LETTER OF SUBMITTAL
KFM Skyway Project # 04-012024

Subject: USI - Documents Clearing USI W M NCR #65 (METS#51)

Reference: SFOBB Skyway Project
USI #23932 (NCR LTR# 65.121604)

Subject: KFM/USI NCR No. 51: Deviating from Approved Fabrication Procedures (Fabrication of soffit plates pal 9 and pa20)

PA9 GIRDER 3A

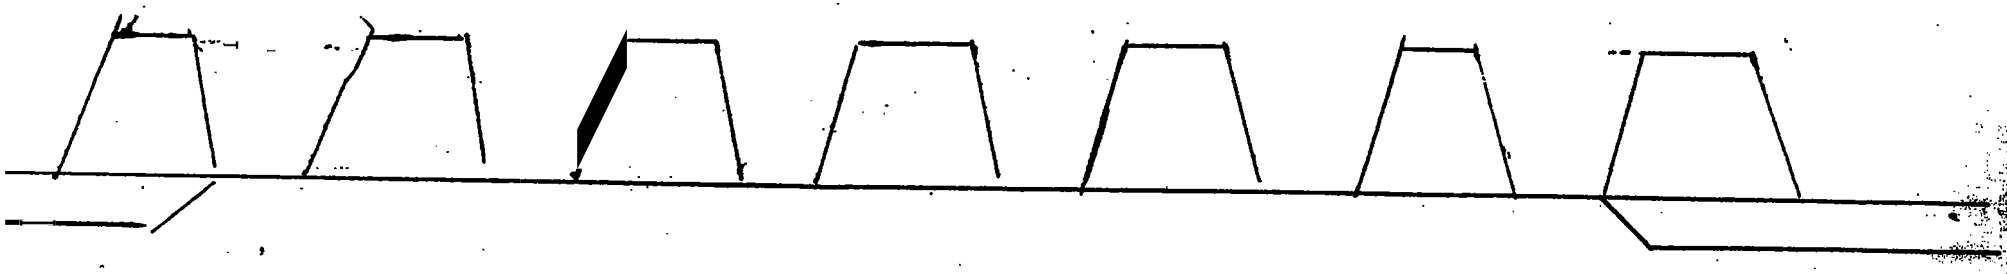
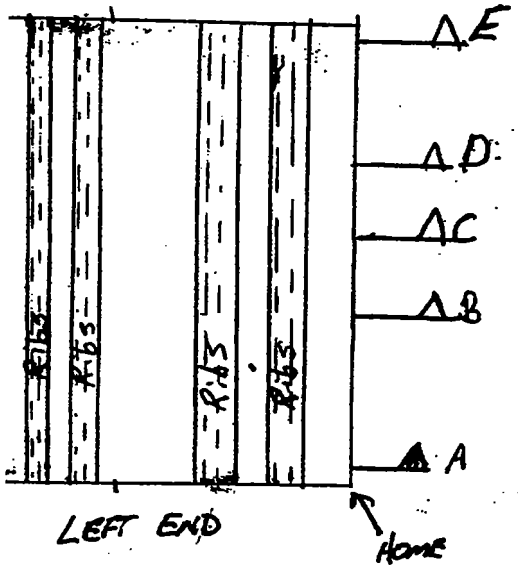
DECK PLATE ASSEMBLY PA9 ON GIRDER 3A HAS WELD DISTORTION - SEE ATTACHED SKETCH

distortion due to welding ribs

Deck Plate Assembly Pa10

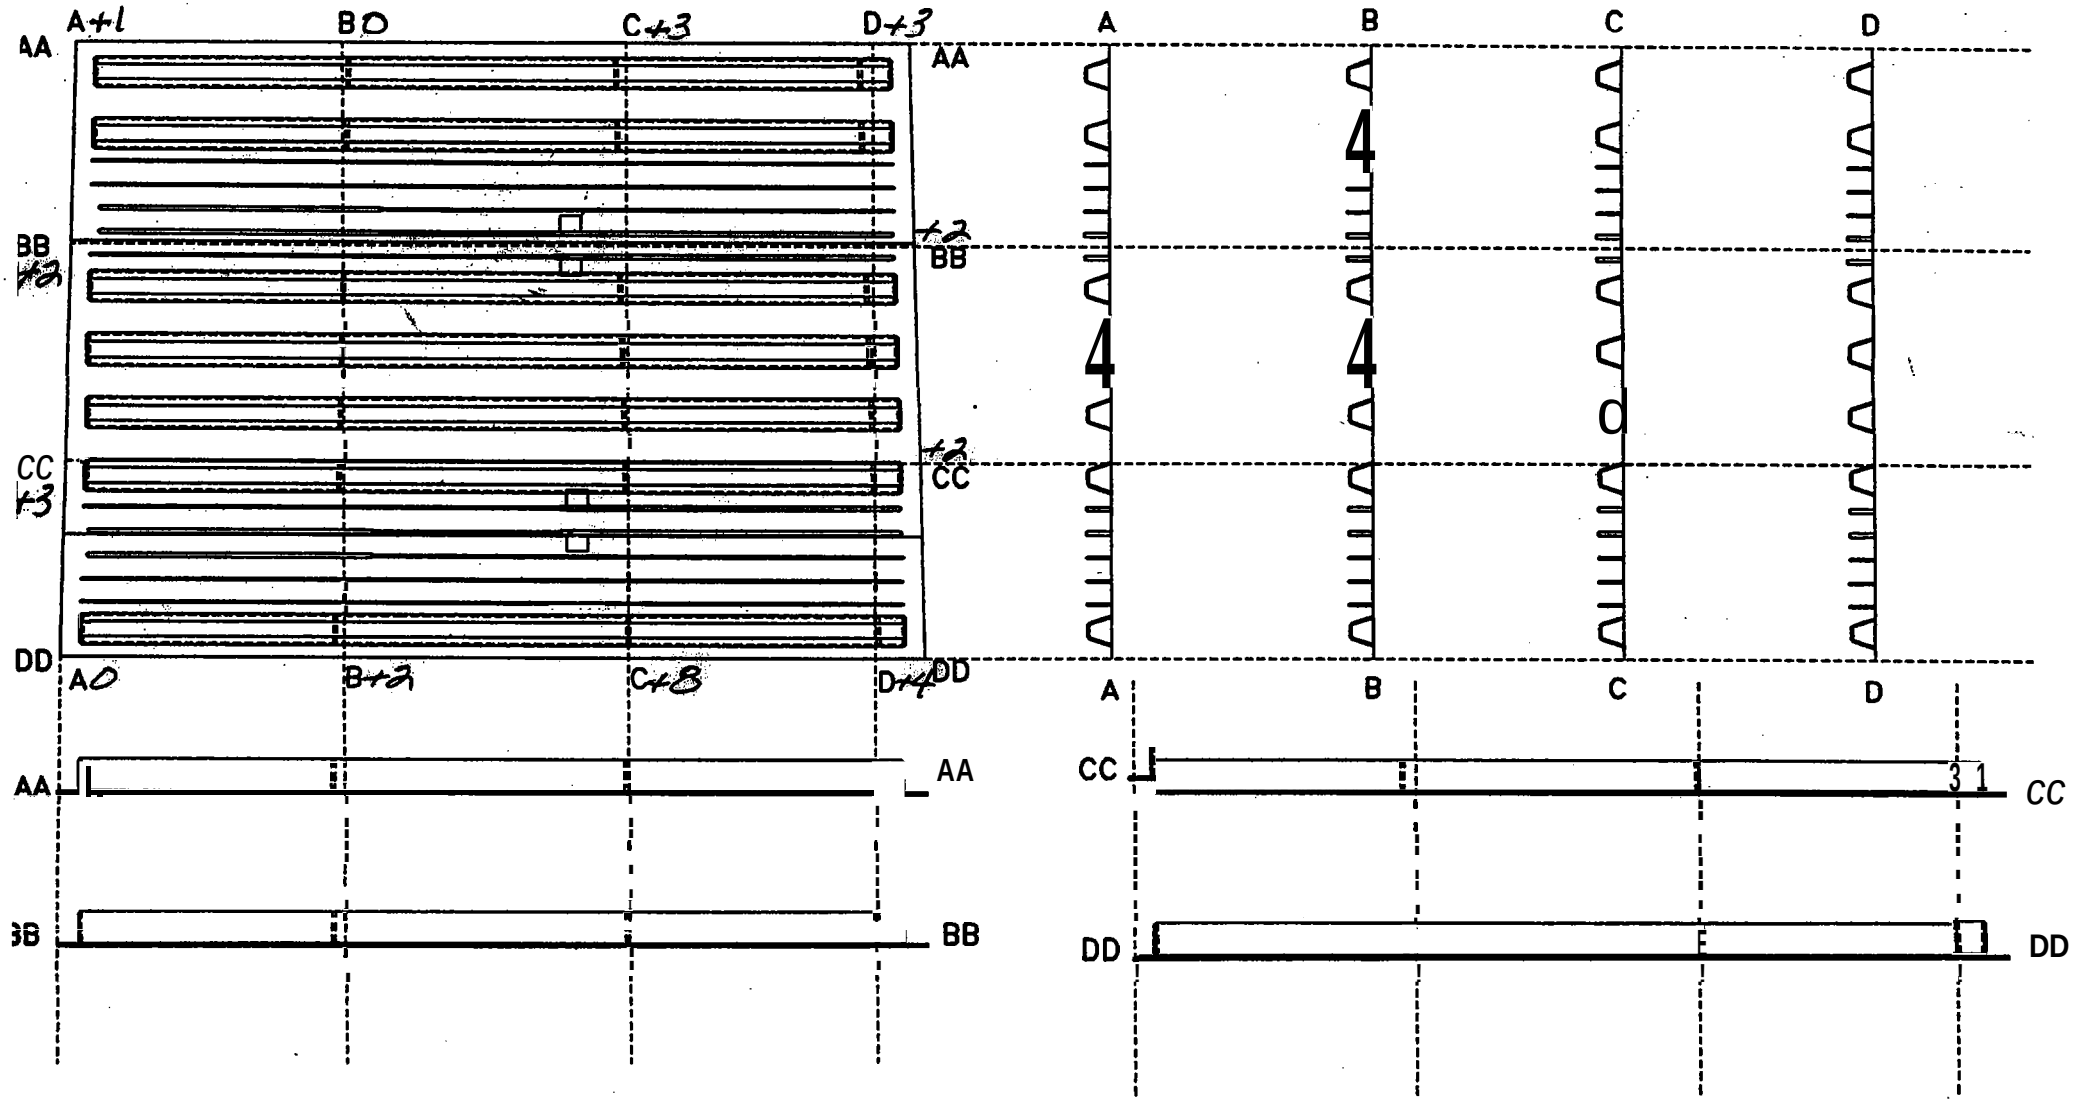
DECK PLATE 10 HAS WELD DISTORTION AFTER WELDING SPLICES. SEE ATTACHED SKETCH. THESE DIMENSIONS ARE WITHOUT THE AID OF WEIGHTS OR CLAMPS TO THE PLATE.

Deck Plate pa11

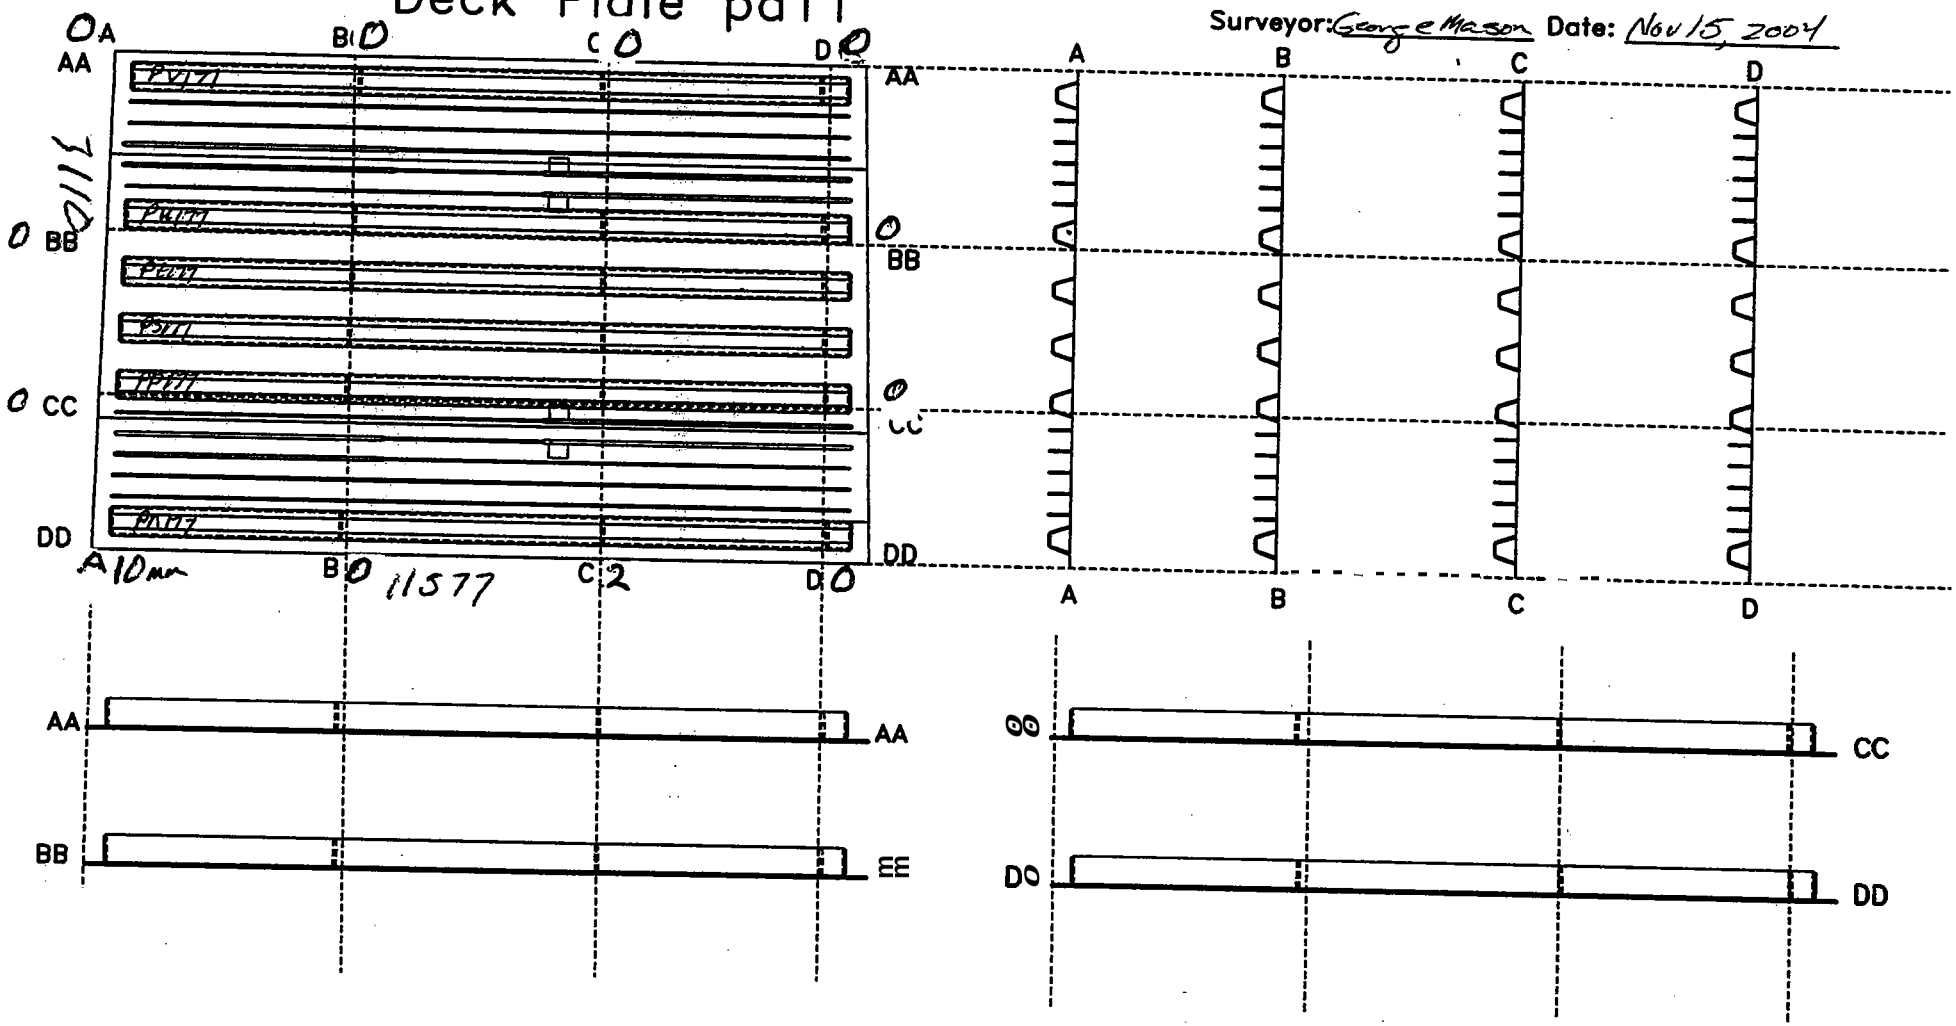
Deck Plate 11a has weld distortion at the Butt splice. See accompanying sketch.

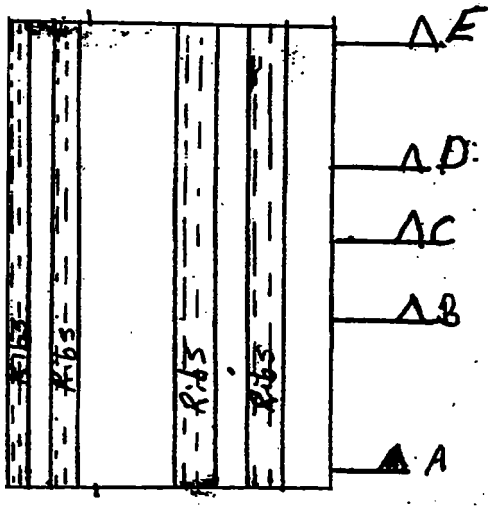
Deck R Pa 12 is Not Flat See attached Drwgs.
i. The numbers on drwg begining with 400 represent the heights as recordeel with a Lazor Level. These numbers were shot in while the bunking was still under it. When we removed the bunking it Laid flat in the Longitudinal direction. This with only the closed ribs welded.

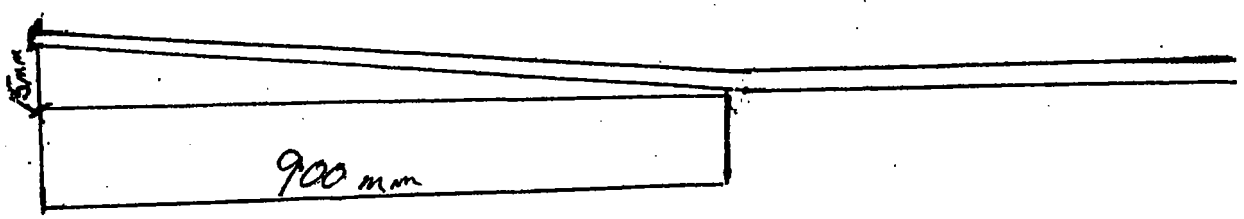
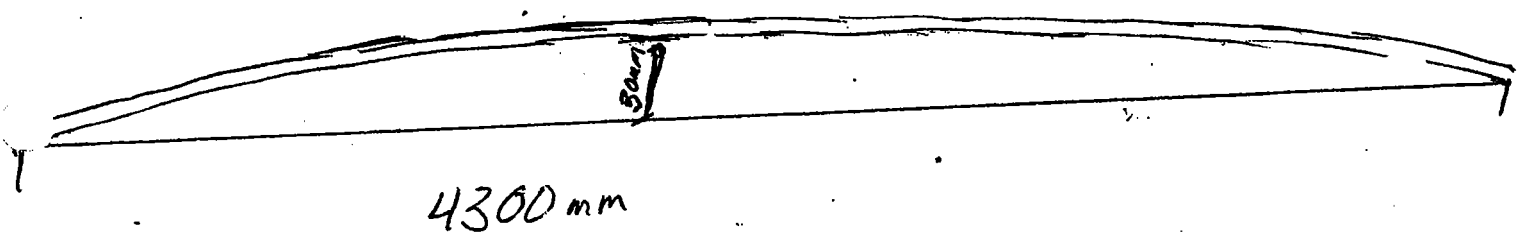
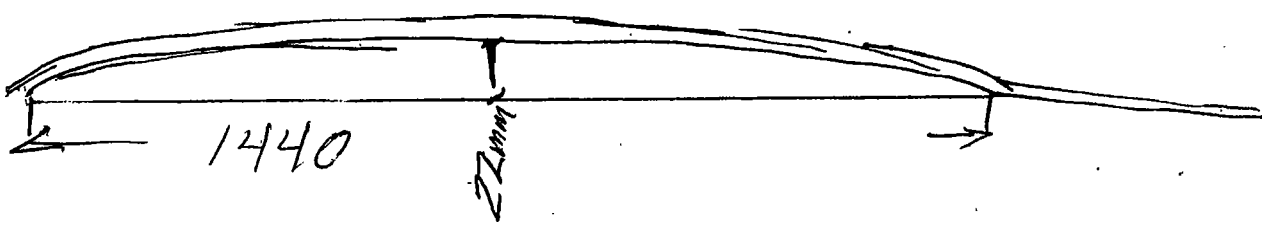
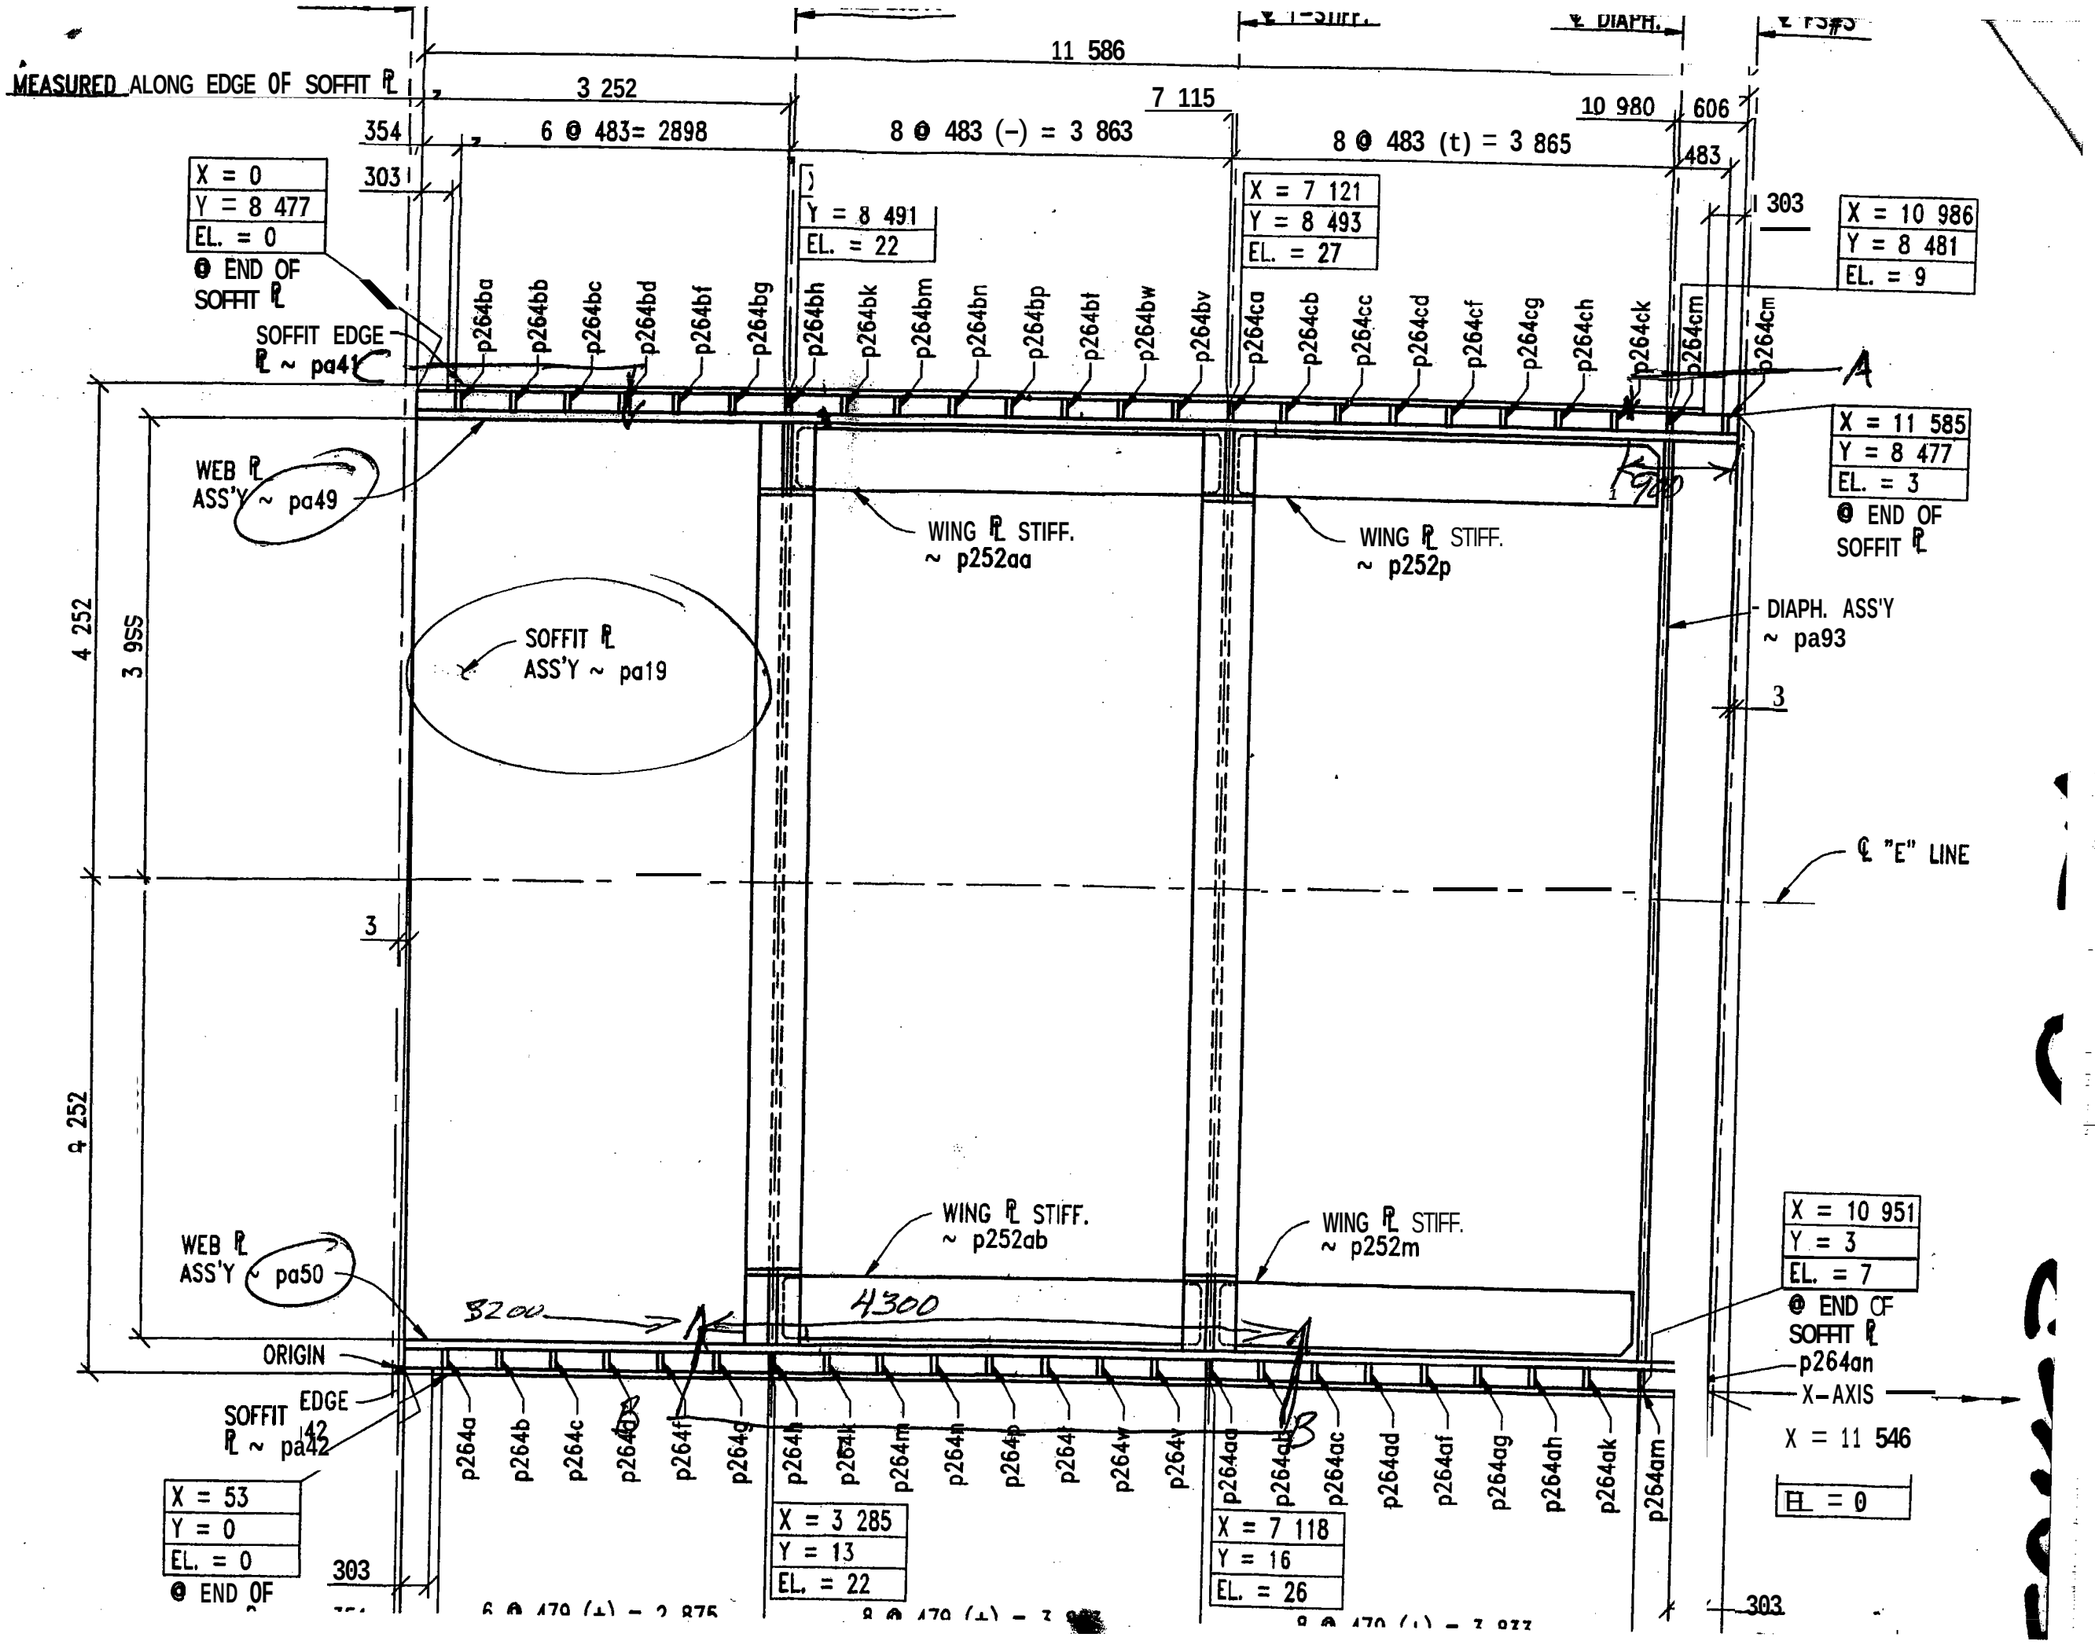
On Girder 3A, soffit pal 9, we have weld weld distortion. (See attached sketch) The first sketch shows the location, the second sketch shows the amount of deviation. The deviation occurs from where the web plates attach to the soffit outward.

SUPPORT WELD WITH BEAMS UNDER DEFLECTION AREA AND CLAMP.

THIS NEEDS TO BE DONE ON 4A GIRDER ALSO AND CHANGE WELD AS FOLLOWS:

PA19

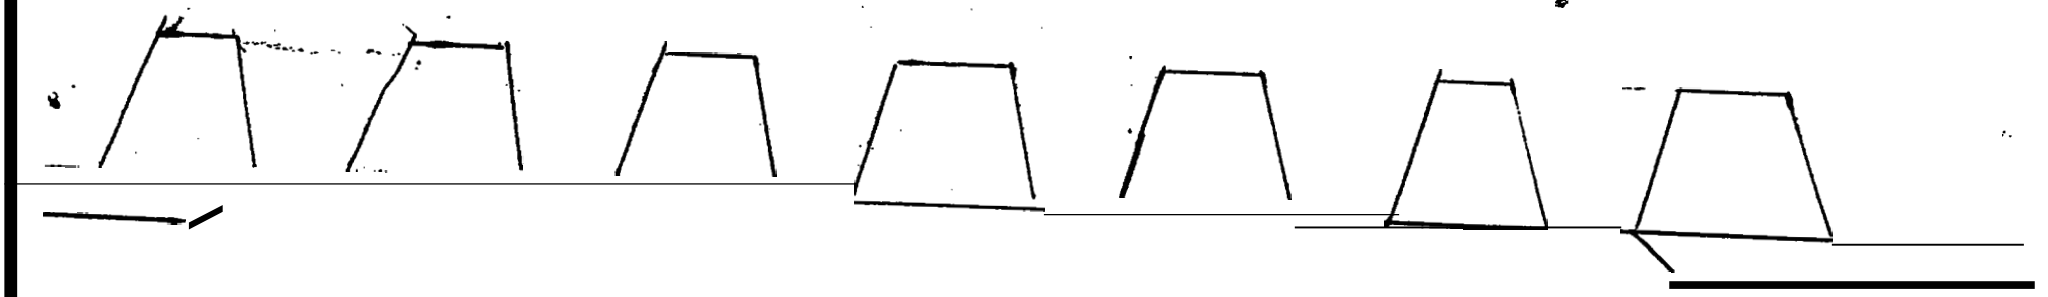
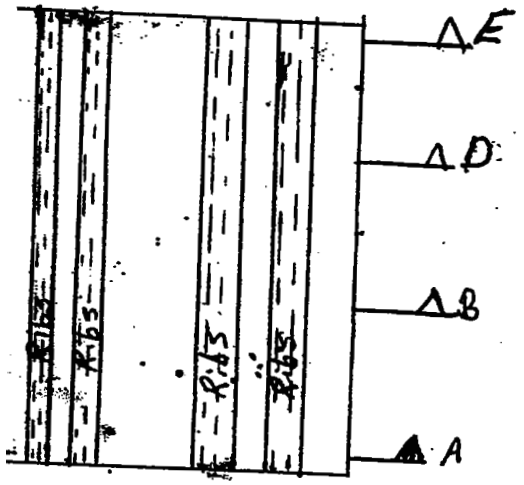
Pa19 has weld distortion. (See attached sketch)

weld distortion due to welding ribs

~~Apply heat as recommend in heat straightening procedure.~~
THIS WAS REVIEWED BY SHOP SUPERINTENDENT AND PLANT MANAGER THAT DIAPHRAMS AND STIFFENERS WILL HOLD PLATE IN POSITION WITHOUT ANY HEAT APPLICATION.

ALL FUTURE PANELS WILL NOT REQUIRE CLAMPS TO BE REMOVED. MEASUREMENTS WILL BE TAKEN WITH CLAMPS IN PLACE. DIAPHRAMS AND STIFFENERS HAVE PROVIDED ADEQUATE SUPPORT TO RETAIN REQUIRED TOLERANCE.
